COUNCIL ASSESSMENT REPORT

Panel Reference	PPS-2019CCI024
DA Number	1392/2019/JP
LGA	The Hills Shire
Proposed Development	Demolition of the Existing Structures and Construction of an Apartment Building Development containing 94 Units and Associated Works
Street Address	11-15 Fishburn Crescent and 28-30 Chapman Avenue Castle Hill
Applicant	Fishburn Group Pty Ltd/
Owners	Mr P Venhuizen, Mrs J R Venhuizen, Mrs C Mancone, Mr M J J Mancone, Mr J M Kok, Mrs S S Kok, Mrs J A Speth, Mr M R Gillies and Mr R C Gillies
Consultant/s	Town Planner: Ethos Urban Pty Ltd Architect: Zhinar Architects Landscape Plans and Report – Paul Scrivener Aboriculture: Redgum Horticultural Engineers: CAM Consulting Surveyor: Survey Plus Acoustic: Acoustic Logic Traffic: Varga Traffic Quantity Surveyor: Construction Consultants Wind Assessment: Windtech BASIX: Taylor Smith Consulting Contamination: Arcadis Access: Vista Access Architects Waste: CBD Core

Figure 1

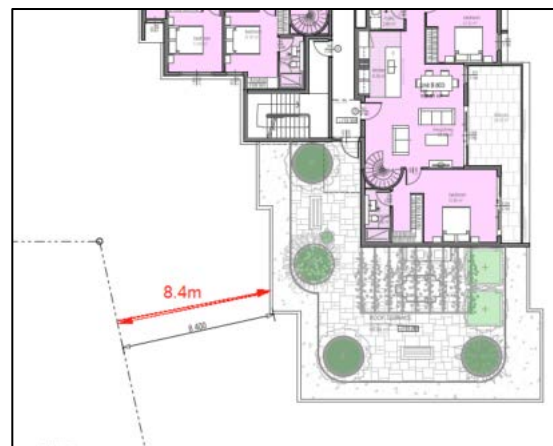
The proposal complies with the external building separation design criteria of the Apartment Design Guide with the exception of the separation distance between Units A504, A604 and A704 in Building A to the southern property boundary (see figure 1) and the roof terrace on the eight storey of Building B to the western property boundary (see figure 2). The Guide recommends 9m building separation to the property boundaries for the 5th to 8th storeys.

It is considered that the encroachments are minor in nature as the habitable rooms windows are highlight windows, balconies are screened by privacy louvres and the roof terrace has been fenced to restrict access so that trafficable areas are at least 10m from the western property boundary. It is noted that the adjoining development to the south is currently under construction and was approved with generous rear setbacks under 320/2019/JP (refer figure 5). The developments would substantially exceed the ADG separation requirements of 18m for up to 4 storeys and 18m for 5 - 8 storeys. Minimal overlooking impacts would occur as a result of the variation and it is considered the proposal affords a reasonable level of visual amenity to adjoining properties.

Figure 5

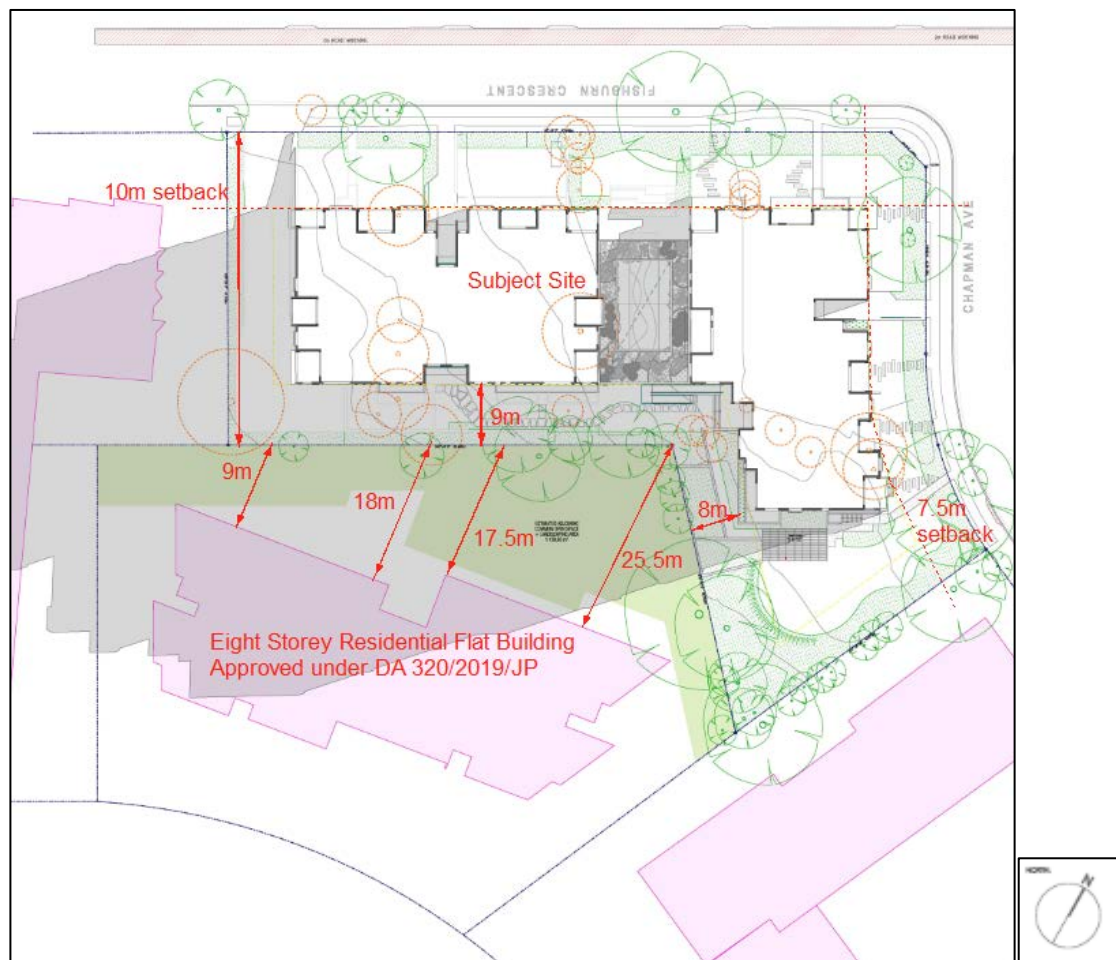
The proposal also results in 68% of the living areas on the adjoining southern property achieving the required 2 hours of solar access during midwinter which does not comply with the ADG design criteria as 2 units on the adjoining development fall short of achieving the required 70%. The adjoining development approved under 320/2019/JP is currently under construction. The rear setback provided to the approved development is generally between 9m – 25.5m and the subject proposal provides a minimum building setback of 8m from the rear boundary which results in a building separation of 18m – 33m. This exceeds the 12m (up to 4 storeys) and 18m (5- 8 storey) building separation as required by the ADG. Refer figure 5 below.

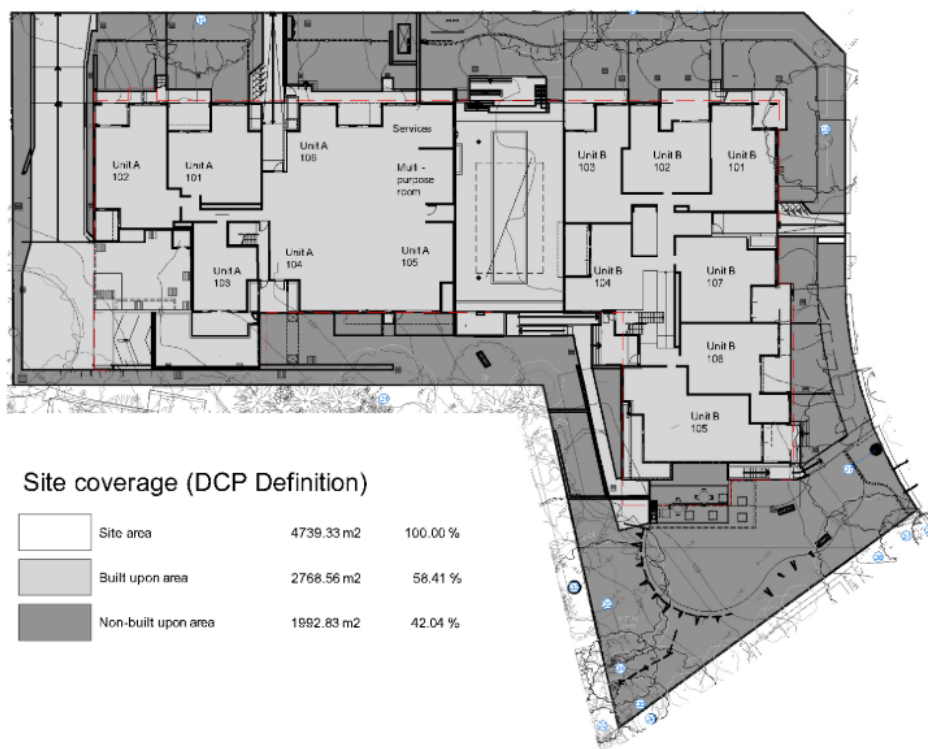
In this respect, we consider that the imposition of a site coverage control that is undefined in the glossary of the DCP and that is supported with a supplementary note on the determination of site coverage is inconsistent with the site coverage definition of the LEP and is therefore contrary to the provisions of the Act. In this regard, it is our view that the site coverage control

should be defined strictly in accordance with the LEP being the prevailing environmental planning instrument, in which case, numerical compliance with the DCP is achieved.

Notwithstanding the above, the proposal would achieve a site coverage of 58% if calculated in accordance with the DCP, noting that this includes the area of all impervious communal open space areas including the footprint of the swimming pool and landscaping features within the building footprint. To achieve 50% site coverage pursuant to the determination of the DCP would require the removal of the driveway, the pool area and the basement below which would significantly undermine the viability of the proposed development.

Site coverage plan 1:400 @ A1
(LEP Definition)

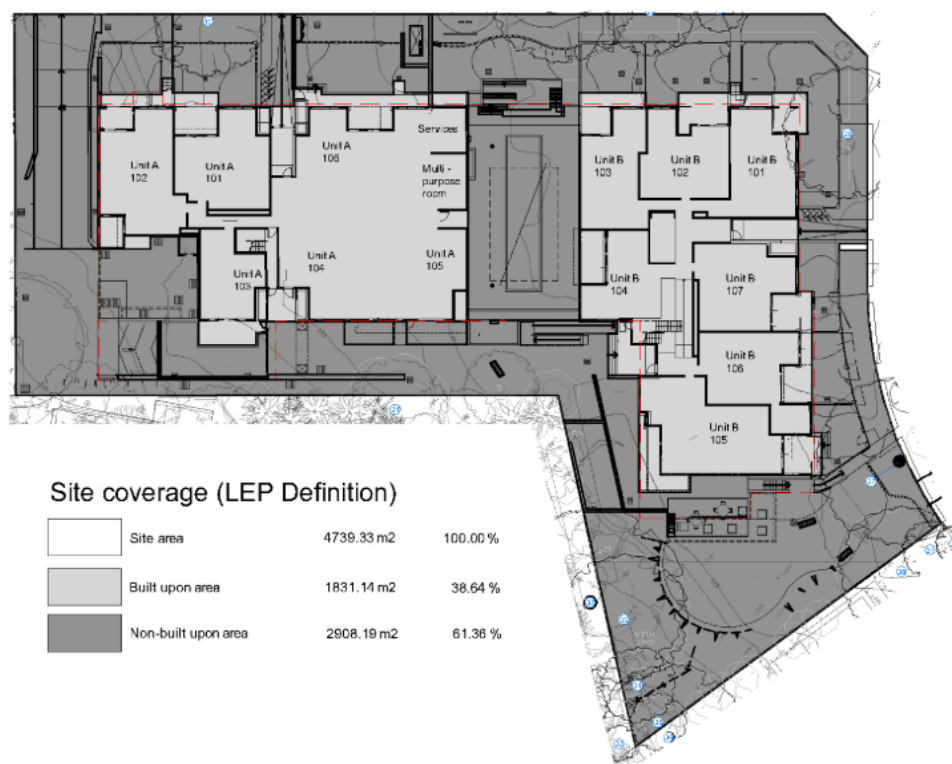
Comment:

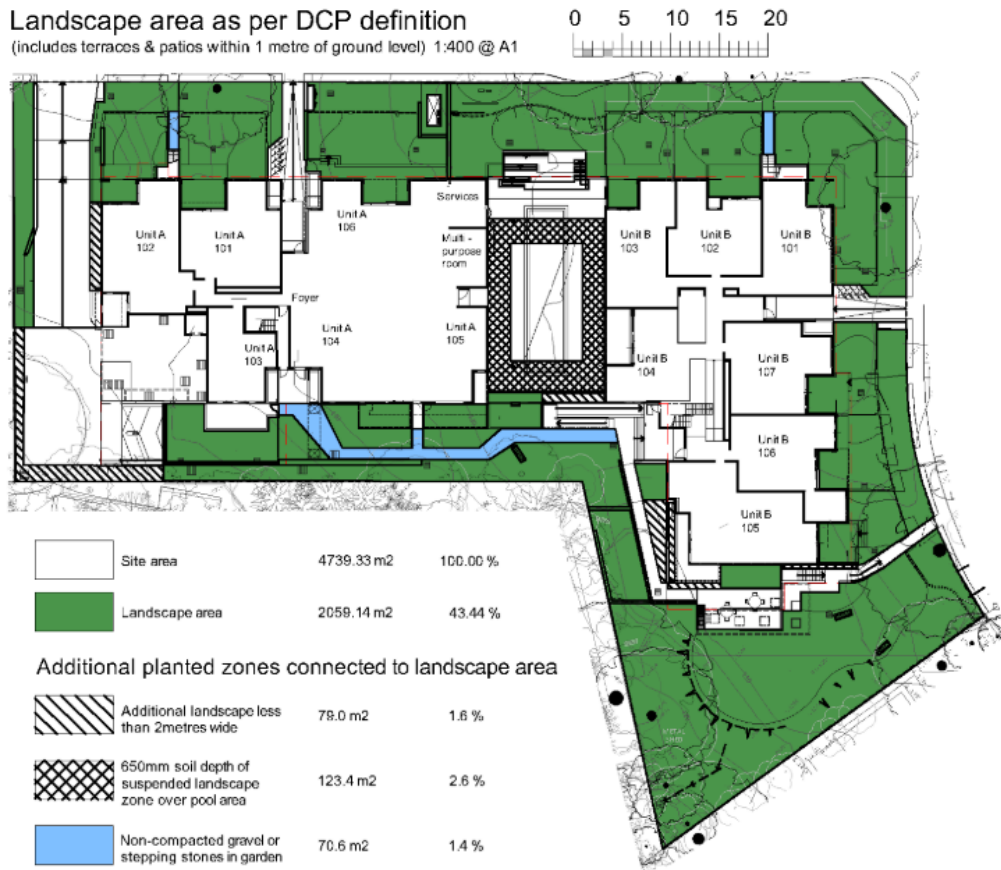
The DCP requires a minimum of 50% of the site area shall be landscaped. The proposal provides for 43% of the site area (2,059m²).

The proposal has been amended to include 2,059m² (43%) of landscaping area which is a marginal shortfall to the landscaped area control of 50%. This has been depicted on Sheet No. 4 of the amended landscaped plans and does not include 337.32m² of communal open space provided on the rooftops of Block A and B nor the entire pool area. These areas are considered to contribute to the landscaping qualities of the development. Notwithstanding the non-compliance, it is critical to note that the proposal significantly exceeds the required deep soil zone of 7% and provides 41% of deep soil zone areas.

Whilst the proposal results in a 7% shortfall to the landscape area control, the development provides for a high quality landscape outcome with 35% deep soil provided for the development. In accordance with the Design Review Panel's recommendations, a comprehensive landscape design has been submitted which indicates that more existing trees are retained, more street trees are provided as required under the public domain plan, larger
